5. Revised DEIS Comments and Responses

This section contains all comments and responses made on the Revised DEIS received by WSDOT during the comment period. The comments and responses are grouped in the following order: federal and state agencies (A), local jurisdictions and representatives (L), comment forms (C), and public hearings (CRO, CRH).

This letter provides the comments of the U.S. Department of the Interior (Department) on the Revised Draft Environmental Impact Statement (RDEIS) and Draft Section 4(f) Evaluation for the proposed SR 509 Corridor Completion/I-5/South Access Road. This project will complete a major north south corridor in a metropolitan area where the existing highway system is inadequate. The present configuration of roads, airport, and essential development and protection zones put significant constraints on locating new highways and appropriate interchanges, as do the natural features such as streams, wetlands, ravines, and the wildlife that inhabit this green space.

Chart 6, Page 2 of 4

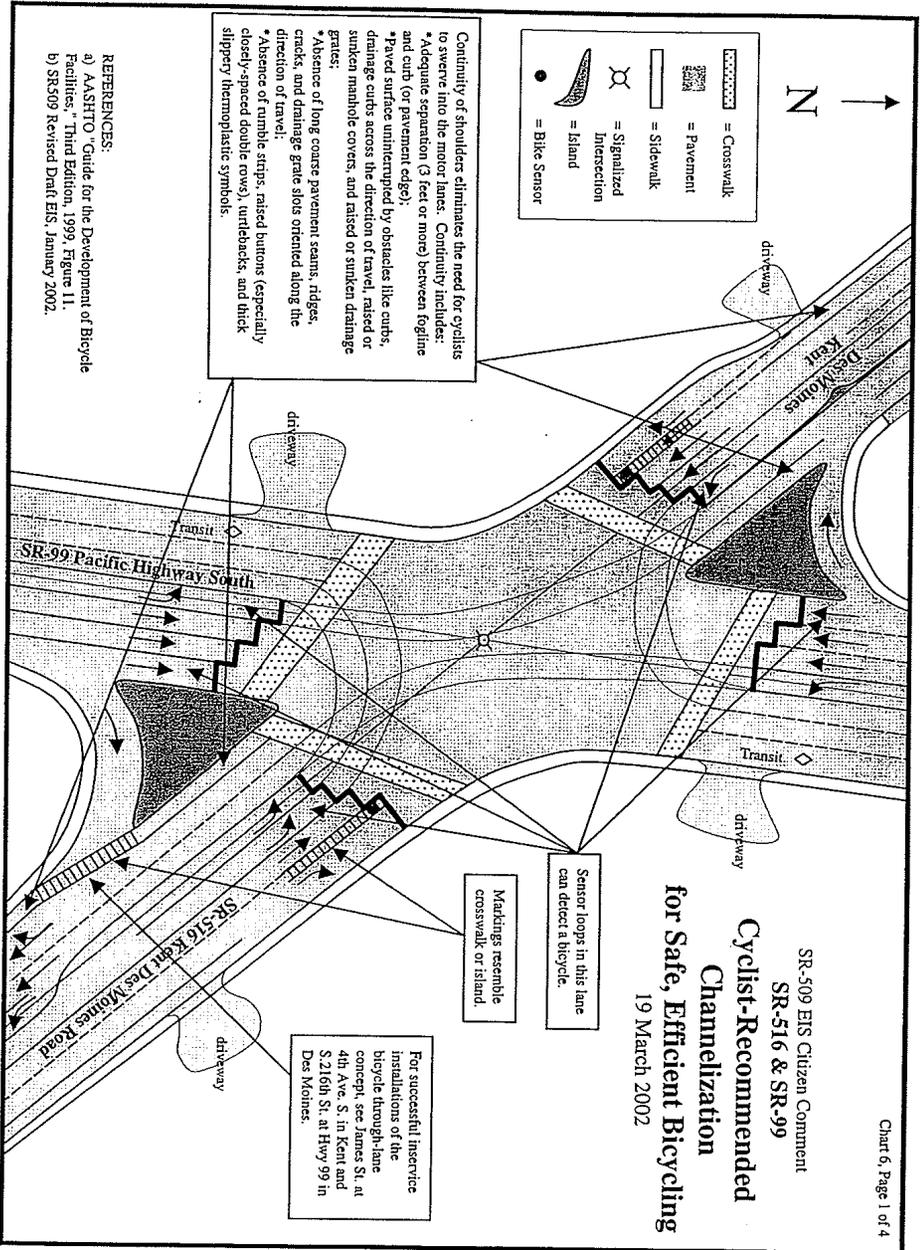
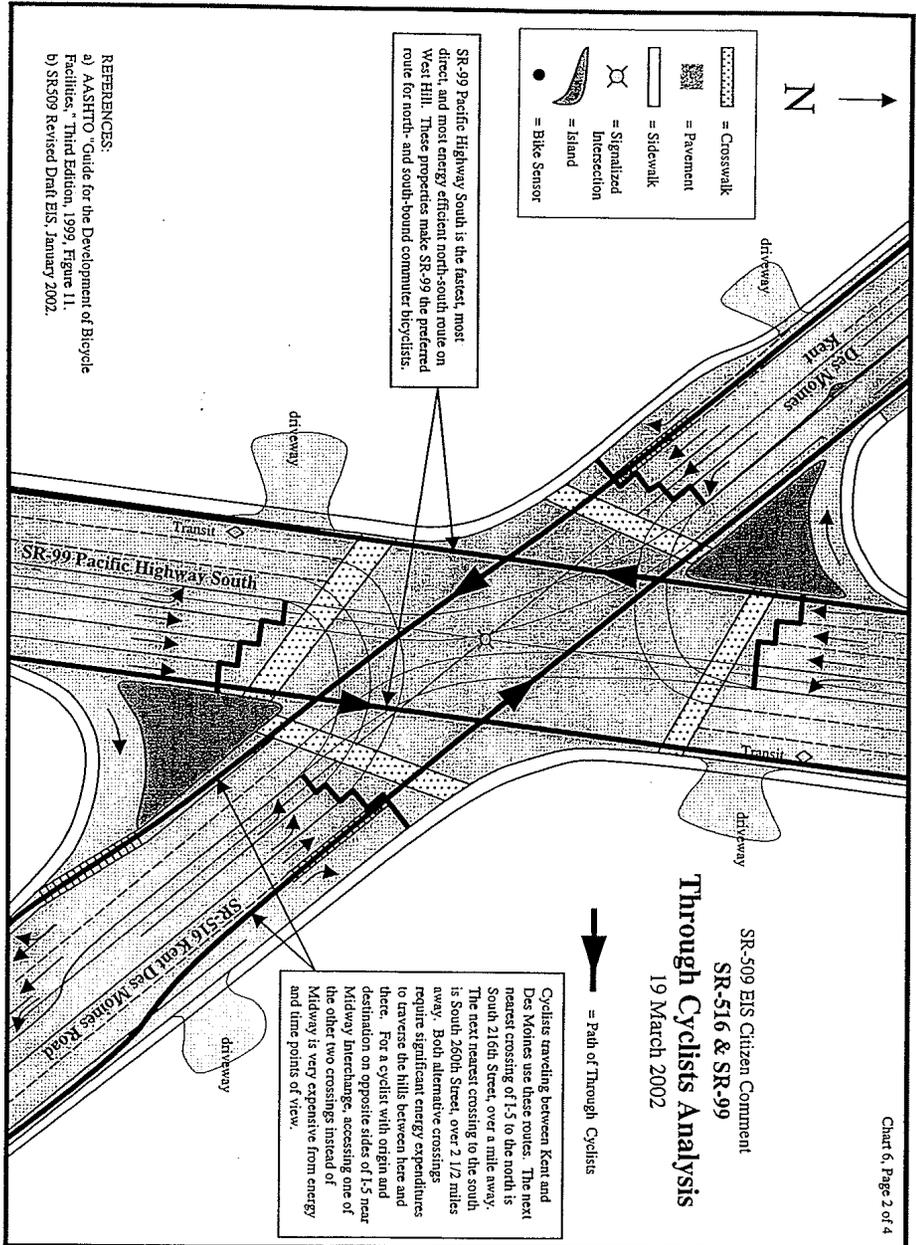
SR-509 EIS Citizen Comment
 SR-516 & SR-99
Through Cyclists Analysis
 19 March 2002

Cyclists traveling between Kent and Des Moines use these routes. The next nearest crossing of I-5 to the north is South 216th Street, over a mile away. The next nearest crossing to the south is South 250th Street, over 2 1/2 miles away. Both alternate crossings require significant energy expenditures to traverse the hills between here and there. For a cyclist with origin and destination on opposite sides of I-5 near Midway Interchange, accessing one of the other two crossings instead of Midway is very expensive from energy and time points of view.
